SYSTEM 80

CESSAR. FSAR

DOCKET STN 50-470

RESPONSES TO QUESTIONS ON CESEC

FIGURE 440.85-1  
STEAM GENERATOR  
INITIALIZATION

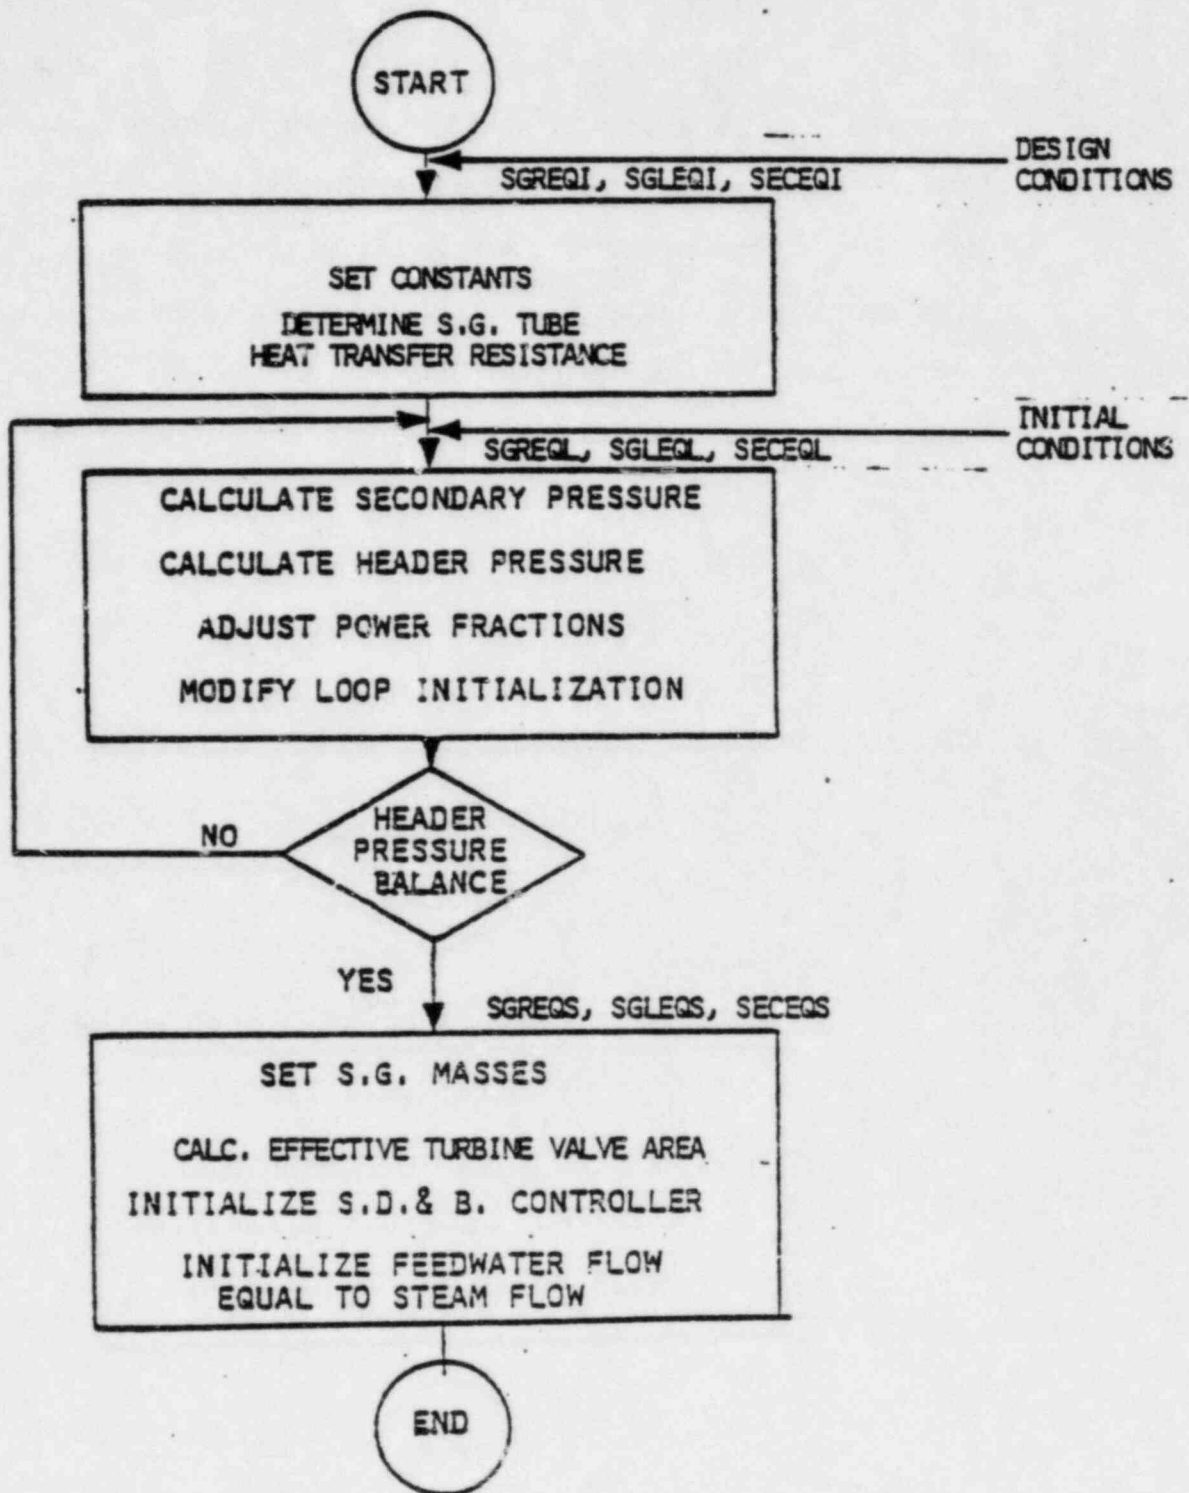
440.85 Describe the self-initialization procedure.  
(440.3)

Figure 440.85-1 details the above steps in block diagram form. The loop at the center of this diagram shows the iterative procedure used to arrive at values for power sharing. Steam line pressure loss is accounted for during this iterative procedure for solving for power sharing. The effective flow loss coefficient for the piping modeled in the header simulation equations (see Figure 15-1A of Ref. 13) is used to calculate the header pressure that would result from the pressure in each steam generator and the steam flow from that generator due to the heat transfer from primary to secondary (i.e., power) in that generator. Iteration is continued until the resultant header pressure calculated from the pressure and steam flow of one generator equals that for the other.

Figure 440.95-1  
Basic geometry of wall heat model

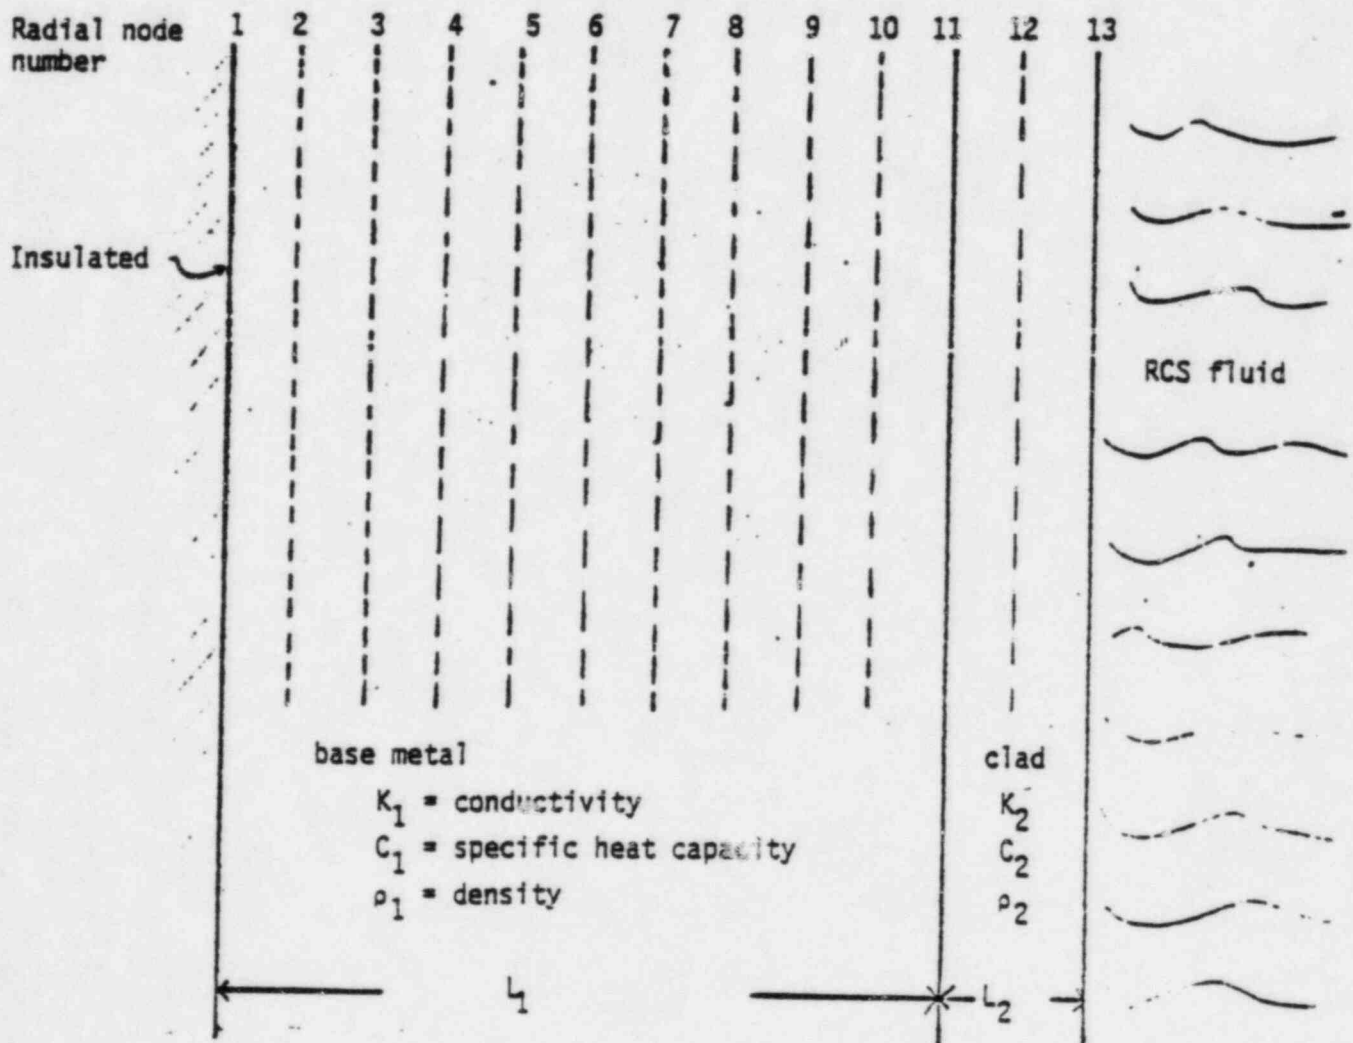
440.95 Are the 13 nodes referred to in the wall heat transfer model radial nodes? Provide a figure for the model to illustrate it.  
(440.13)

The 13 nodes are referred to in the wall heat transfer model are radial nodes. Figure 440.95-1 presents the basic geometry of the wall heat model in the thermal hydraulic node.

FIGURE 440.109-1  
 REYNOLDS-NUMBER FACTOR  
 VS  
 RECIPROCAL MARTINELLI PARAMETER

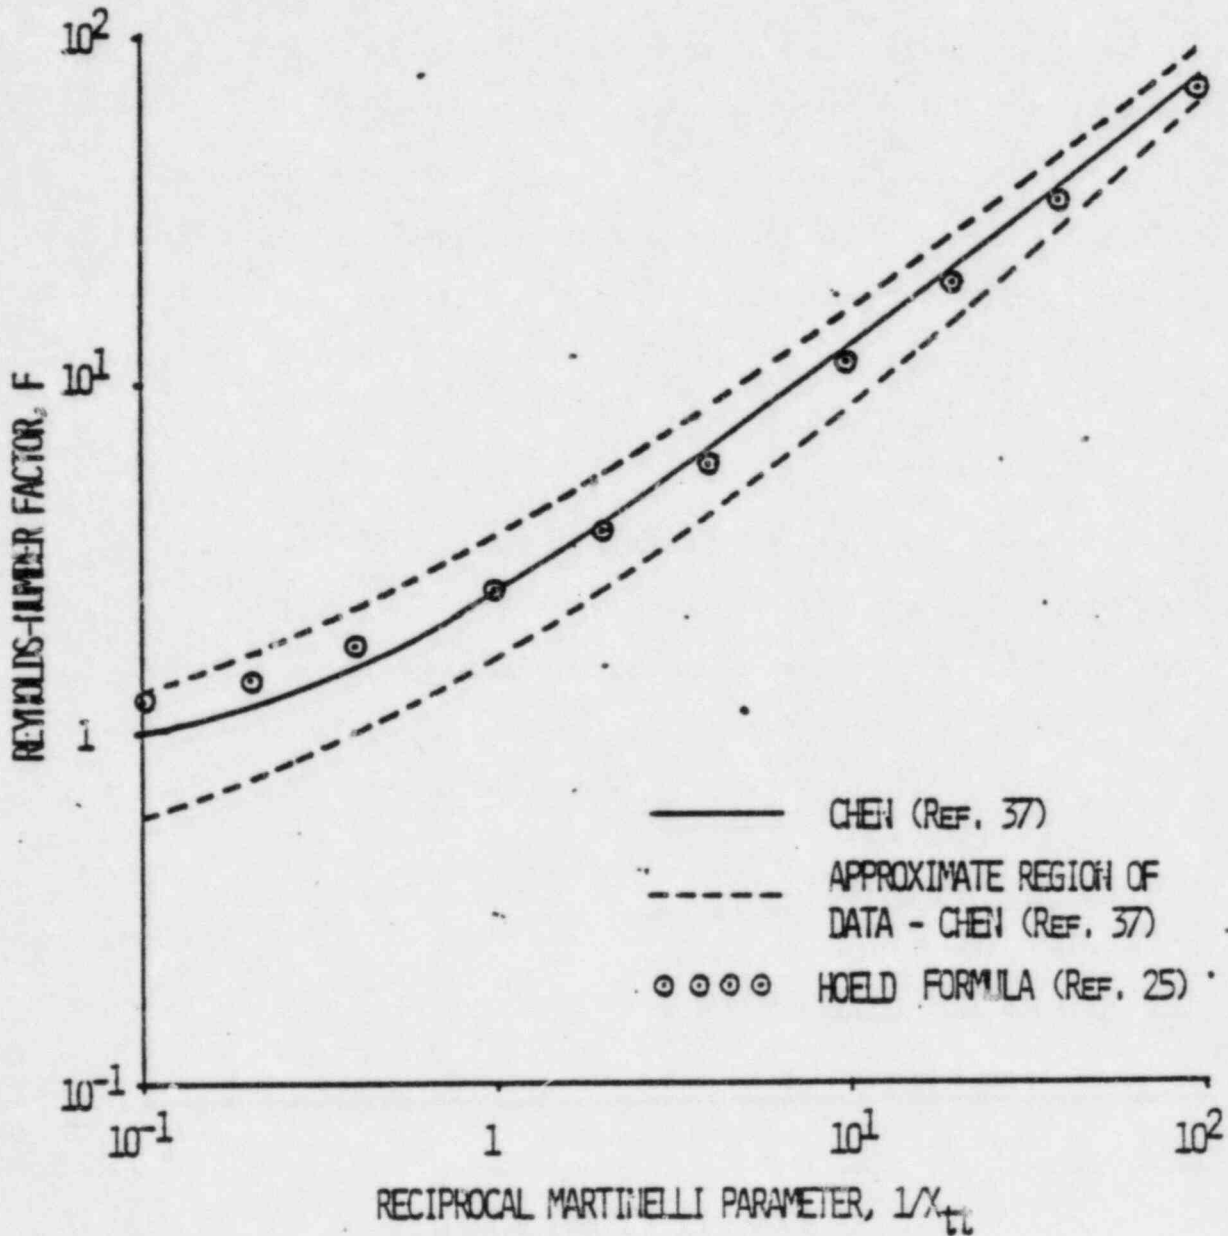
- 440.109 (a) Why does the suppression factor  $S$ , given by eq. (13-9) not  
(440.27) correspond with the formula given in Table 2 of the Hoeld+  
paper referenced?
- (b) Provide references/explanation for the difference in functional  
dependence between Chen's suppression factor\*  $f(Re_p F^{1.25})$   
and Hoeld's expression  $f(1-x) Re_p F^{-1.25}$ .
- (c) Justify the choice of Hoeld's formula for the Reynold's number  
factor,  $F$ , eq. (13-8) over the original Chen values.

When the Hoeld functional fit is compared to the Chen data (Reference 37), reasonable agreement is observed (See Figure 440.109-1). For these reasons the Hoeld expression for the Reynolds-number Factor is used in the CESEC-III code.

FIGURE 440.150-1  
CESEC FLOW PATHS FOR REACTOR VESSEL REGION

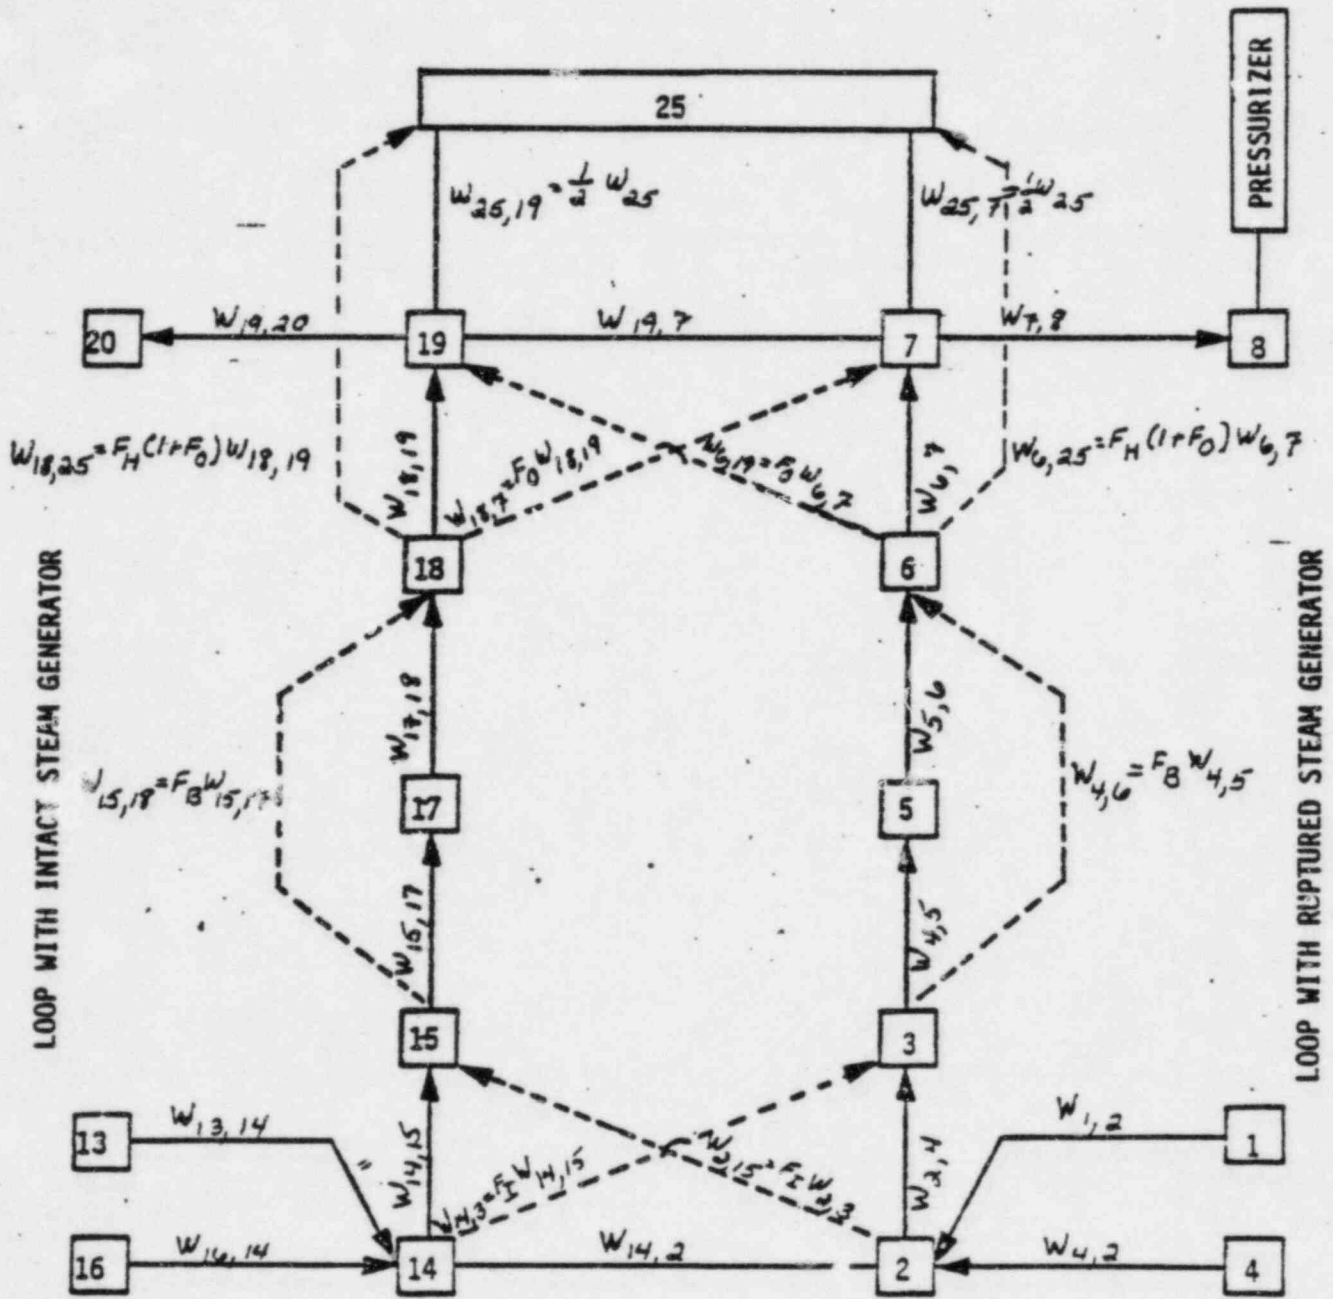
440.150 In general, it is our impression that the data<sup>(1)</sup> presented by  
(440.68) FP&L is sufficient to support a general mixing model since only one  
flow condition was measured. Furthermore, the particular flow  
condition chosen has a Reynolds number nearly one full order of  
magnitude below operating conditions.

Thus it is our general opinion that this single data point is not an  
adequate basis upon which to build a computer code model intended to  
model a wide range of flow conditions. The following specific  
questions should be addressed by the applicant.

Figure 440.150-1 illustrates the flow paths in the CESEC model for the reactor vessel region. This figure is the same as the reactor vessel region of Figure 2-1 of the CESEC Report (Reference 13). The following discussion will focus on the "cross flows,"  $W_{14,2}$  and  $W_{19,7}$  (or "density driven terms") and on the "mixing flows,"  $W_{2,15}$ ,  $W_{14,3}$ ,  $W_{6,19}$ , and  $W_{18,7}$  (or "hardwired terms"). The "cross flows,"  $W_{14,2}$  and  $W_{19,7}$ , are determined by direct solution of the thermal hydraulic equations (Eqns. 2-1 and 2-2) of Ref. 13). The "mixing flows" are calculated as described on p. 2-2 of Ref. 13 using experimentally determined mixing factors,  $F_I$  and  $F_0$ :
